Proposed Change 1819

Code Reference(s):	**NBC20 Div.B 9.36.5.10. (first printing)**
	NBC20 Div.B 9.36.5.14. (first printing)
	NBC20 Div.B 9.36.6.4. (first printing)
	NBC20 Div.B 9.36.7.3. (first printing)
Subject:	Airtightness
Title:	Removing ACH_{50} and Harmonizing Airtightness Requirements in Section 9.36.
Description:	This proposed change replaces ACH_{50} with NLR_{50} as the regulating airtightness metric in Section 9.36. and revises the airtightness requirements in the compliance paths and for proposed house modeling.
Related Proposed Change(s):	PCF 1954

Figure 2. SV trend by house volume

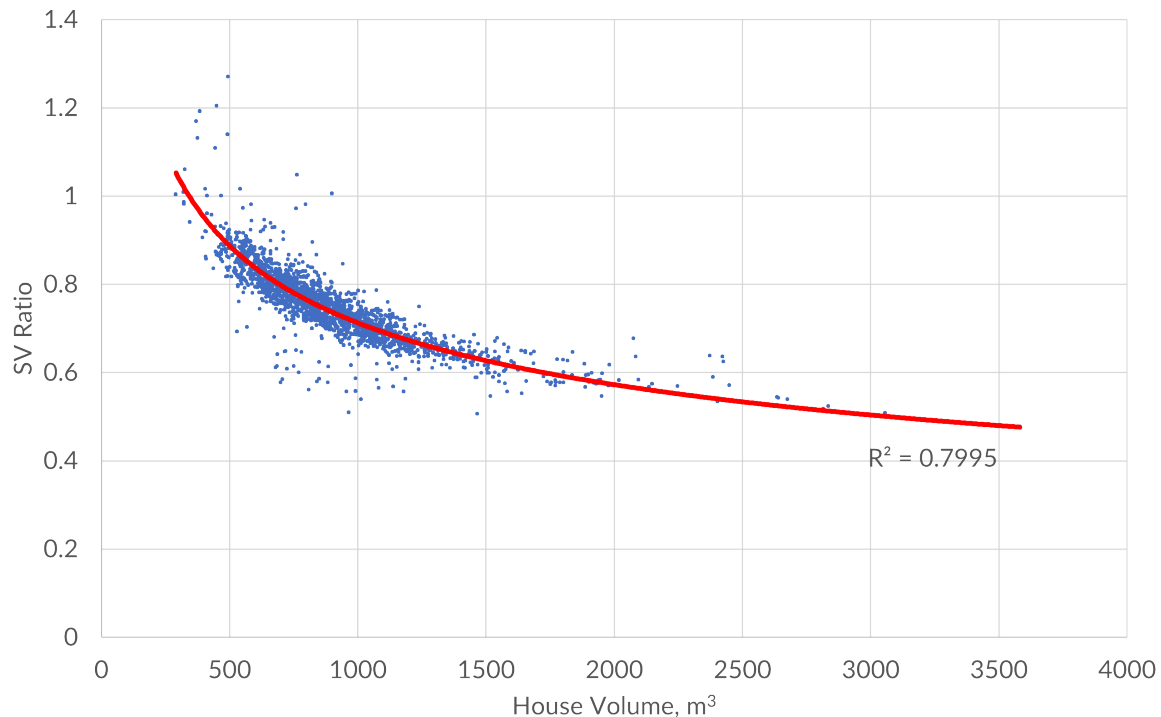
An analysis of the typical relationship of SV to house volume in 8 117 homes in Ontario is shown in Figure 2. The data shows that as houses grow in size, they tend to have a lower SV.

Currently, larger houses (with lower SV) comply more readily with required ACH_{50} targets, so the removal of this metric would require an improvement in the airtightness of assemblies for these houses. For example, if using an NLR_{50} target of 0.89 L/(s×m^2) (i.e., AL-1A) for a 1 500 m^3 house with an SV of 0.62, the equivalent ACH_{50} target is 1.99. The reference house would also now use an ACH_{50} of 1.99 in this instance. This represents a 20.5% reduction in the targeted ACH_{50} value.
